BROOKHAVEN NATIONAL LABORATORY

Meeting Notice

SUBJECT: U-Line Operation

Fig 1 : Radiation Levels on Berm

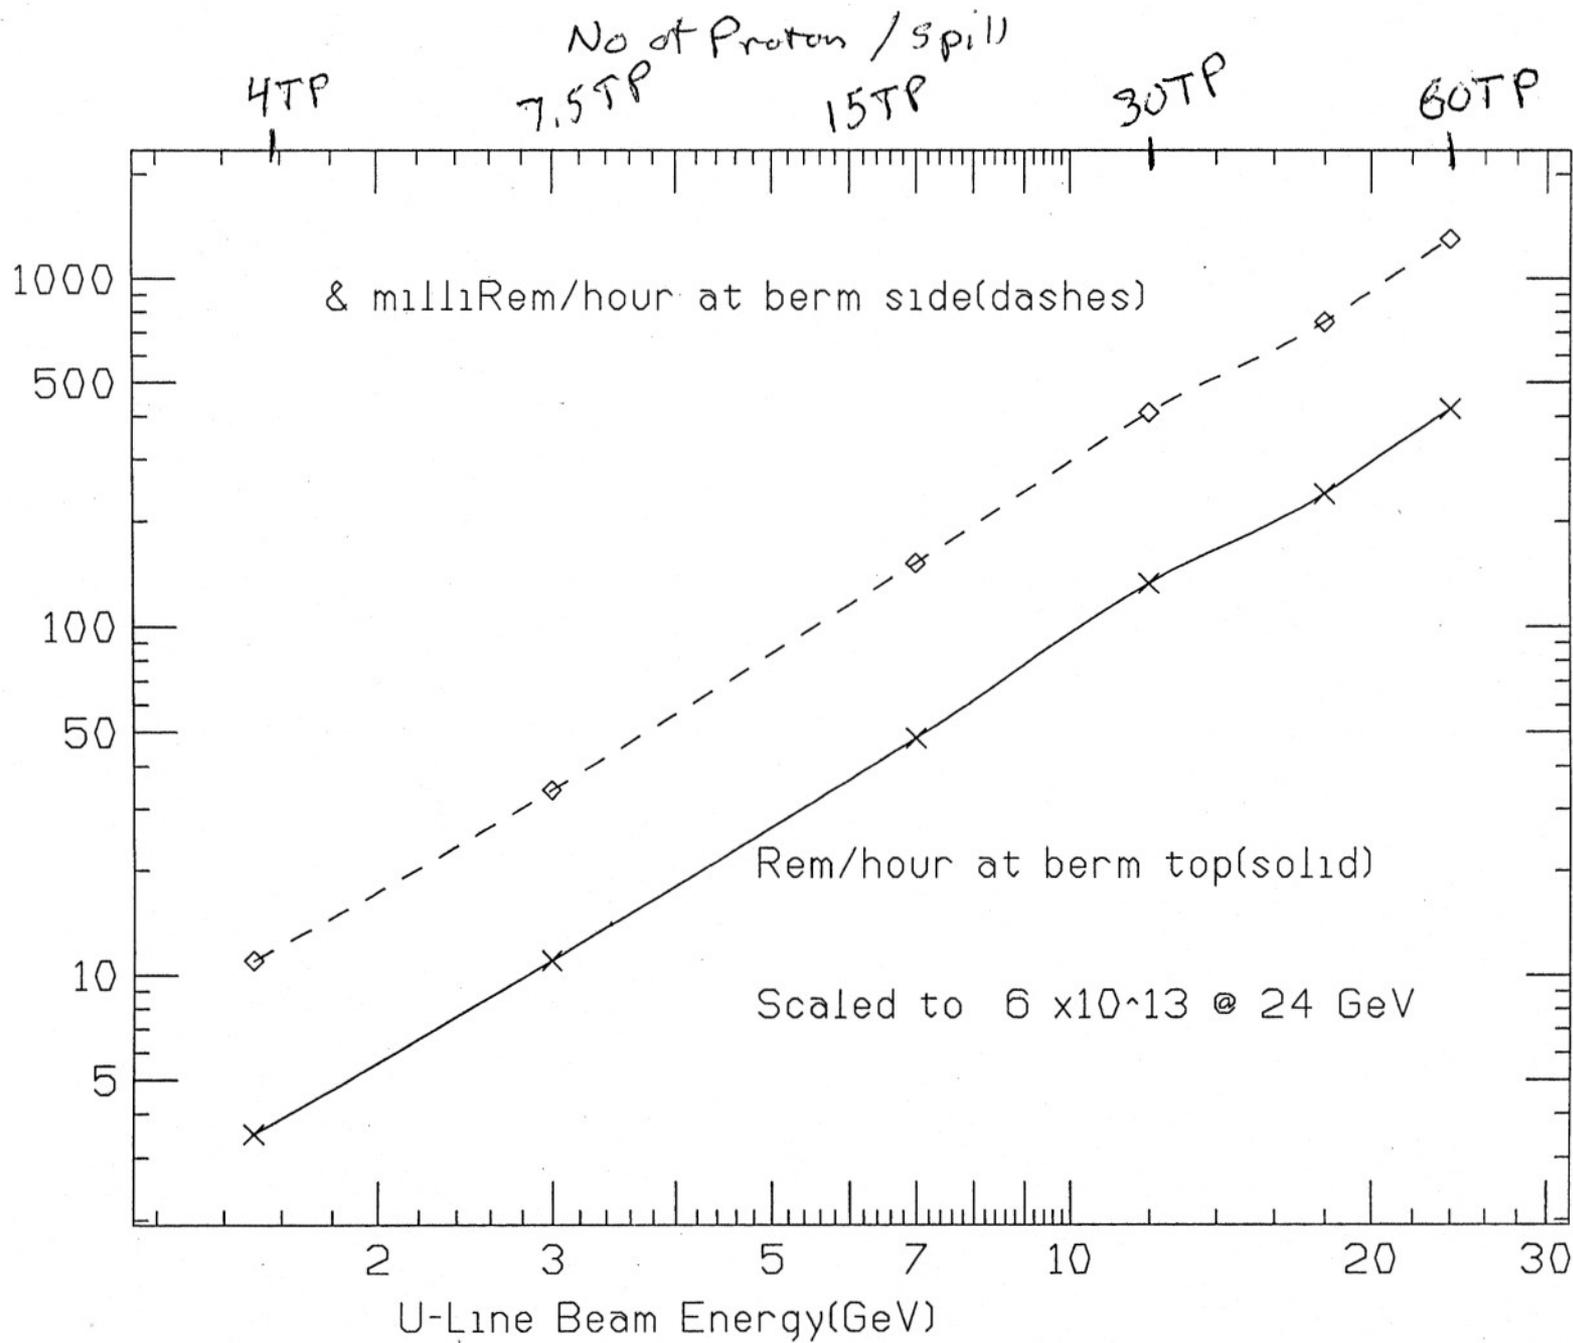
With the present shielding using the Moyer Model for an 11 foot person (a correction for sky shine), the level at 24 GeV for a solid fault with 60 TP is 6 mRem (see Fig 1 and 2) at the edge of the berm. If we move the boundary back 50 feet from the berm, the level would be 1 mRem. The 3 Chipmunks along the berm (midway between the top and edge) would have received a dose of up to 50 mRem, and tripped at a setting of 2.5 mRem. We would integrate the outputs of the Chipmunks in the MCR, and then administratively keep the beam within compliance. I will try to do these calculations more accurately using a sky-shine model. *check*

For the low energy (1.6 GeV) end of the experiments, the shielding us a 50 foot boundary back from the berm should allow for continuous running at energies of 1.6 GeV and below (See Fig 1). The Chipmunks will be active and we will integrate the dose in the MCR.] -

Fig 2. Berm Cross Section with 1.6 GeV Radiation Levels

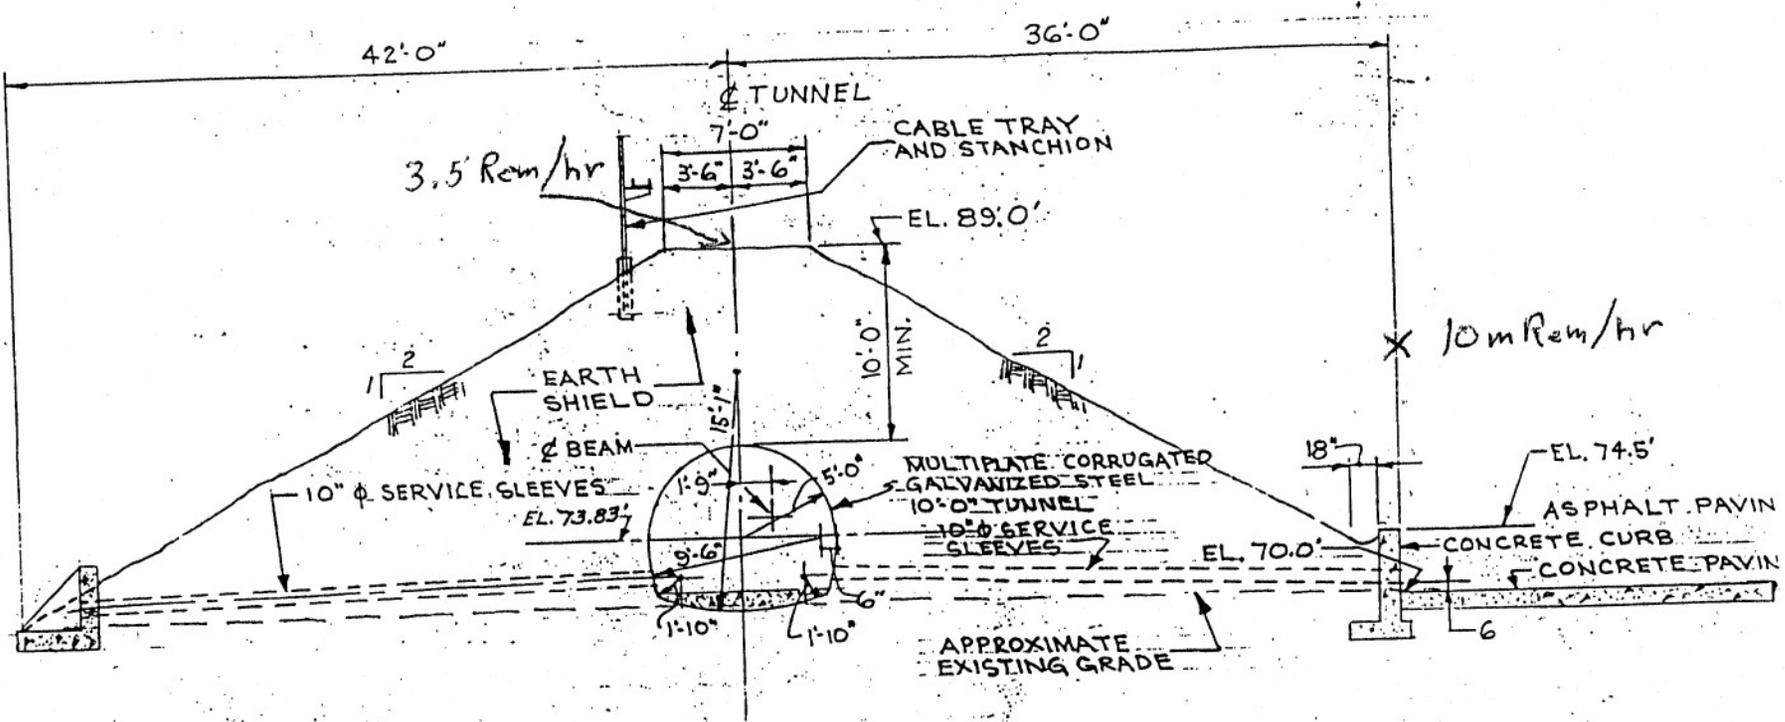
** RADIATION SAFETY COMMITTEE should consider the benefits of increasing berm thickness from 10 feet to 20 feet in the thin region. Estimated cost is <\$100K. Would it simplify RHIC as well as these AGS operations? *check*
